APPLICATION FOR SUBMITTAL OF POST-APPROVAL DOCUMENT

School District/Owner: Yuba Community College District	DSA File Number: 58 C1
Project Name/School: Woodlland Community College	DSA Application Number 02 118286

see attached Addendum 2 for Narrative

1 P203 PLUMBING ROOF PLAN

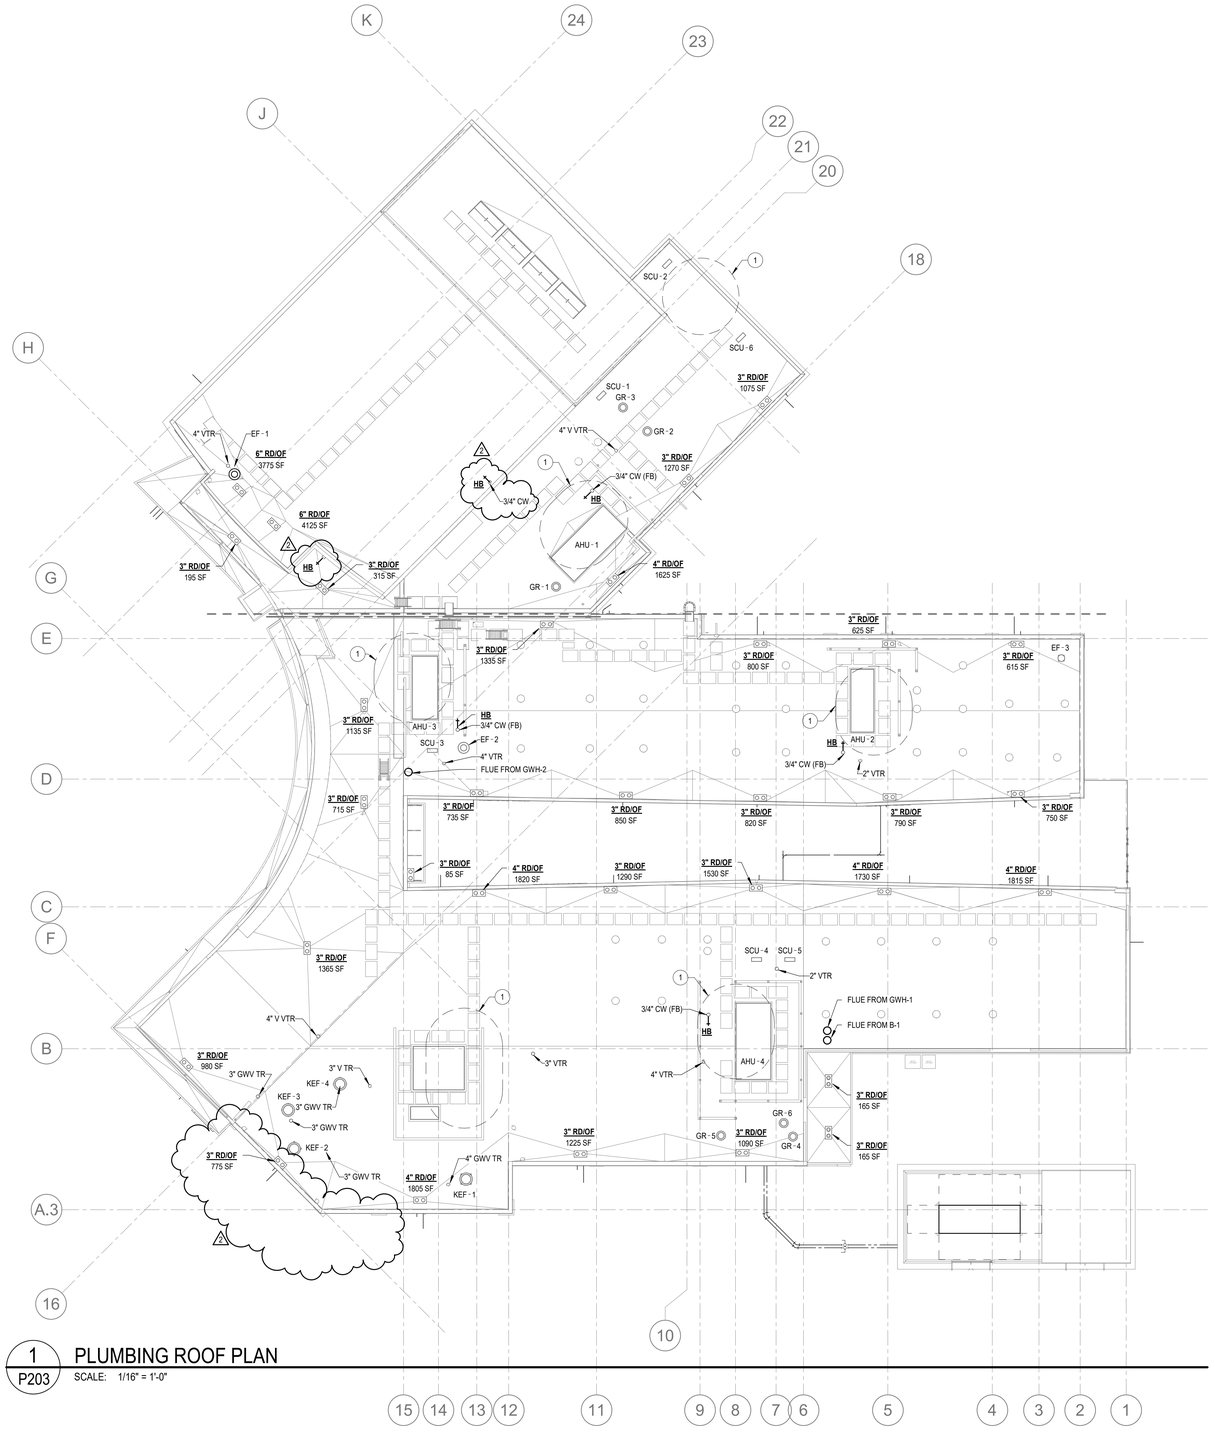
h. P203
   i. Add hose bibb HB in two high roof locations
   ii. Remove southwest corner exterior canopy (not in scope)
